**RE: The Wymont  
4315 Wyoming Blvd NE  
Grading and Drainage Plans  
Engineer's Stamp Date: 01/27/22  
Hydrology File: G19D004**

**RE: The Wymont  
4315 Wyoming Blvd NE  
Grading and Drainage Plans (G19D004)**

Per the correspondence dated December 27, 2021, please find the following responses addressing the comments listed below:

<b>THE WYMONT ALBUQUERQUE, NM</b>	DRAWN BY pm
	<b>STORM SEWER PLAN</b>	DATE 1-27-2022
	<b>TIERRA WEST, LLC</b> 5571 MIDWAY PARK BL NE ALBUQUERQUE, NEW MEXICO 87109 (505) 858-3100 www.tierrawestllc.com	DRAWING 2021008-GR
		SHEET # <b>GR-4</b>
		JOB # 2021008

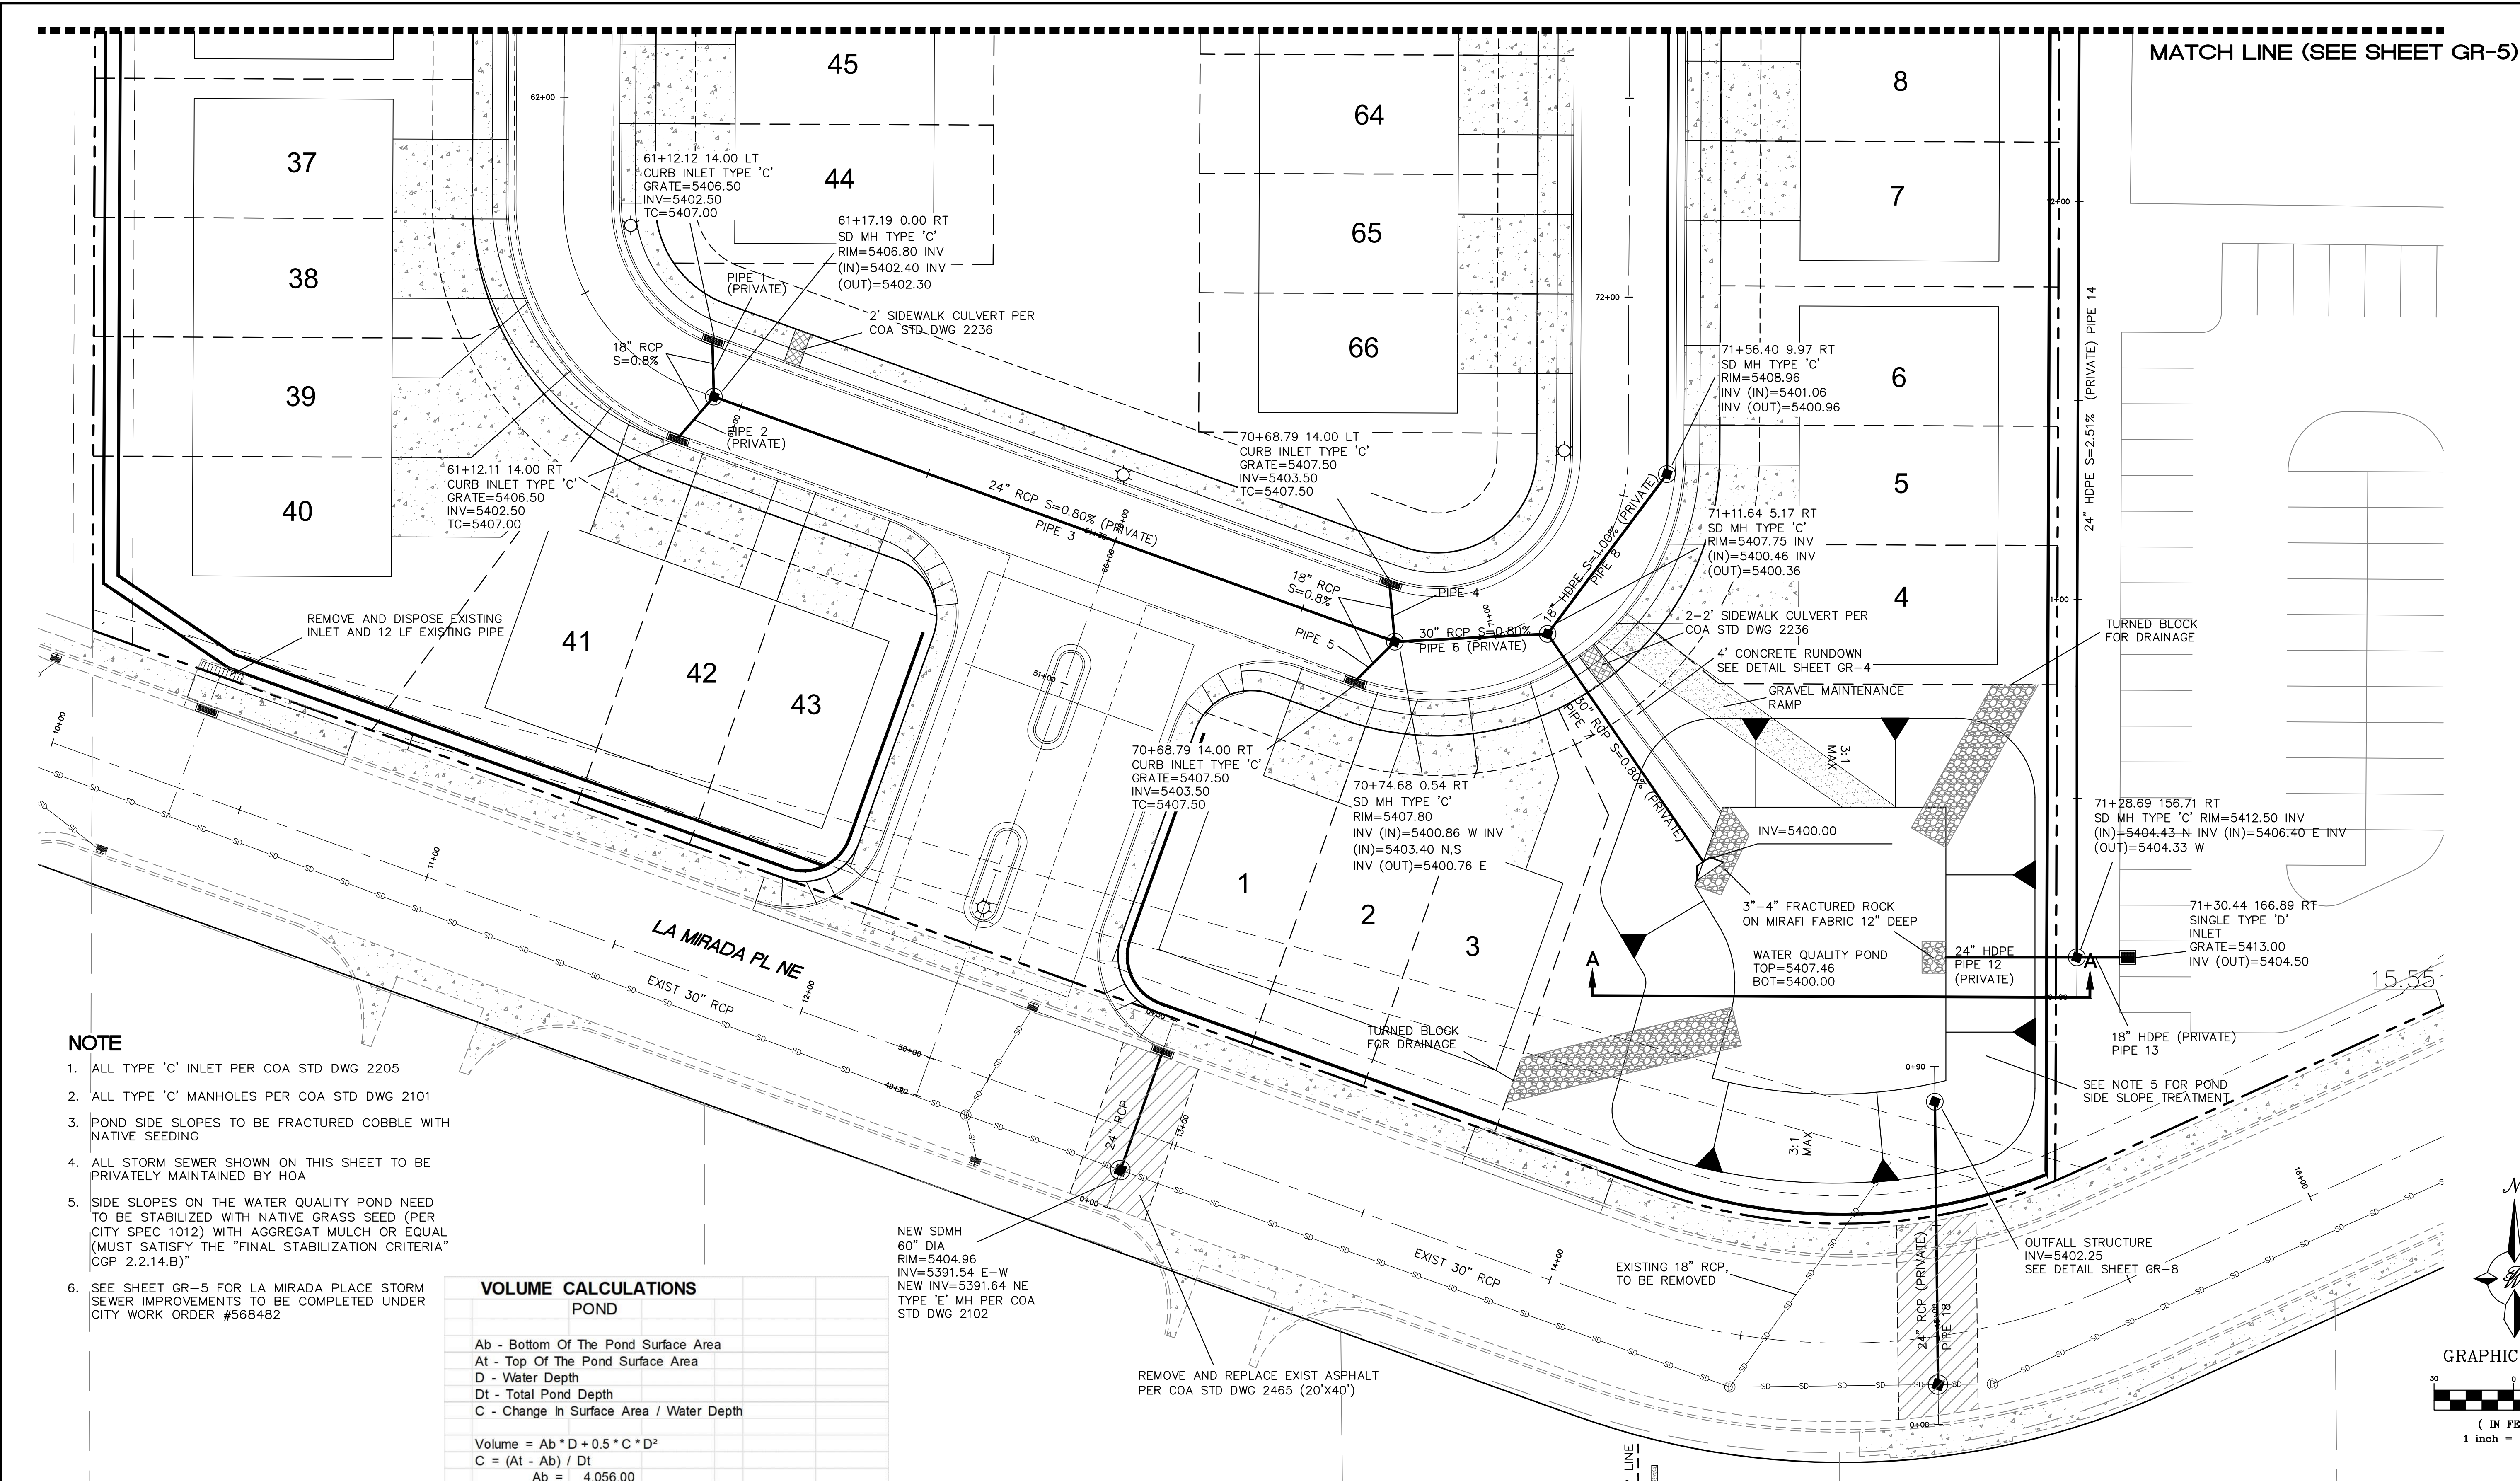
10. GR-4. Please provide the weir calculations, per DPM Article 6-16(A), for the concrete channel(s). A coefficient of 2.7 is typically used for the weir equation  $Q = CLH^{2/3}$ . **The weir calculations were updated with the coefficient of 2.7 and they are shown on Sheet GR-2.**

12. GR-4. Please provide the orifice calculation for the 7/8" orifice plate. **The orifice plate reference was deleted as no orifice plate is required for this project.**

OUTFALL DETAIL  
NTS

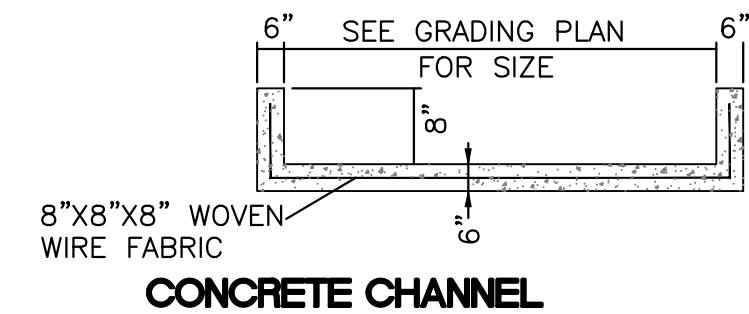
11. GR-4. Outfall Detail. Please provide the bottom of pond elevation, water quality elevation, top of pond elevation, and the elevation of the beehive top. **This information is now included on the outfall detail now found on Sheet GR-8.**
